SGW-59673
Revision 0

Monthly RCRA Groundwater Meeting Minutes September 23, 2015 with Ecology

The objective of this meeting was to brief Ecology on the content of the interim status groundwater monitoring plans for 216-A-29 Ditch, 216-B-3 Pond and Ditch, and LLWMA-2.

Gradient Areas and Proposed 216-A-29 Monitoring

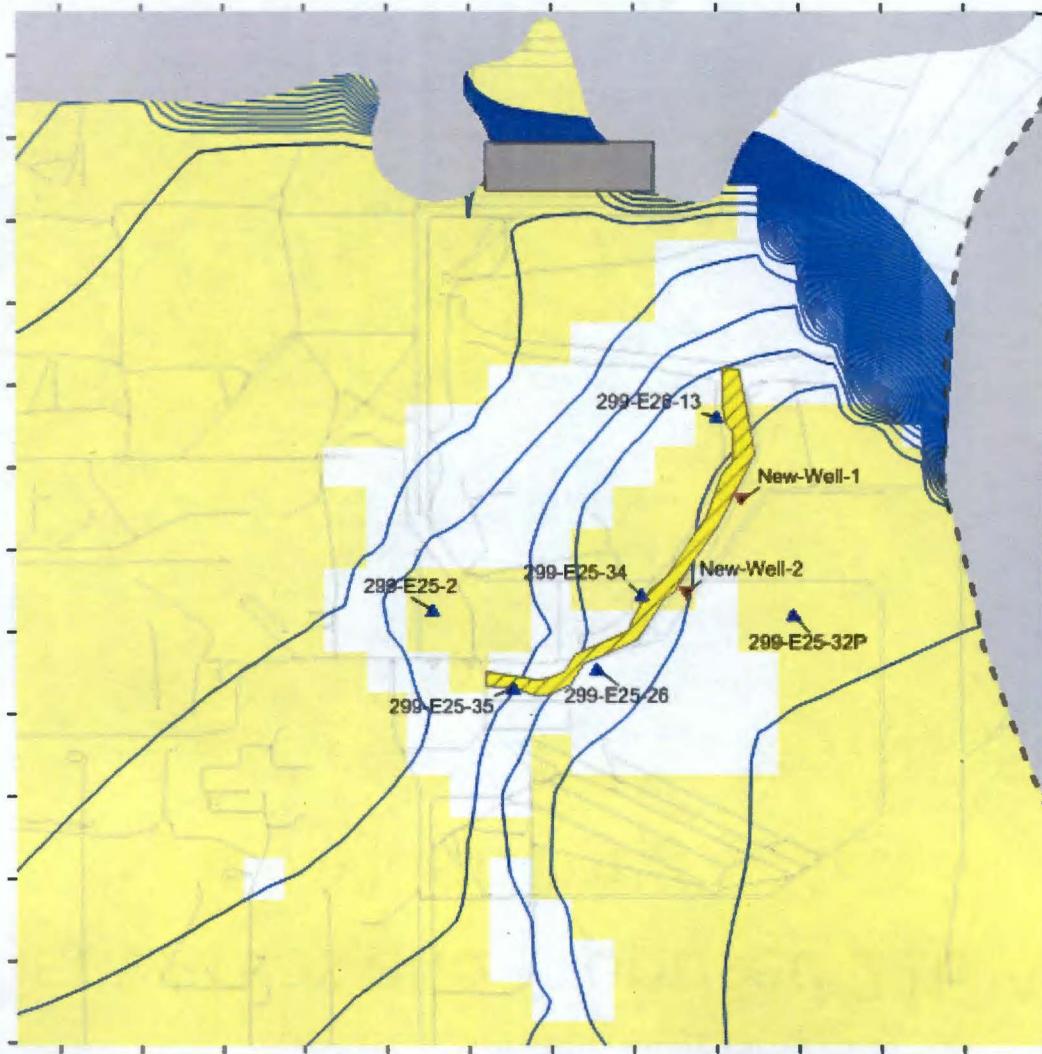
- Defined best locations for 2 new monitoring wells based on transport model simulations for the draft revised monitoring plan.
- Discussed Dispersivity values in the model.

- Wells locations discussed for A-29 are acceptable to Ecology for the draft plan.
- LLWMA-2 discussion was very brief and the group agreed that the draft plan should be submitted for Ecology review. The changes proposed in the draft plan include: deleting alkalinity, changing frequency of site specific constituents and GW quality parameters from semi-annual to annual, change monitoring well network to better align to GW flow direction (west-southwest to southwest).
